Re: Notice in accordancewith Regulation 18(3)(b) of the Waste water Discharge (Authorisation) Regulations 2007

Application: D0052-01 - Mallow Town & Environs

APPLICATION FORWWDL FOR MALLOW TOWN & ENVIRONS REF NO. D0052-01

Response to Notice in accordance with Regulation 18(3)(b) of the Waste Water Discharge (Authorisation) Regulation 2007-dated 04 April 2008

Figure 2 Secondary discharge point SW 2

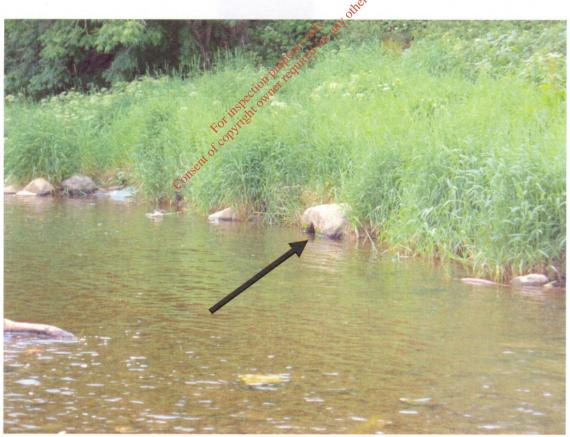
1) Provide the location of the discharge point, in particular, the secondary discharge points, and a description of the outfall design and construction as specified in section B and C.2 of the application form.

Response: Secondary Discharge Point shown on Map Mallow 07 (Section B Attachment B.4) Outfall Design is 3DWF and Pipe Diameter 450mm.
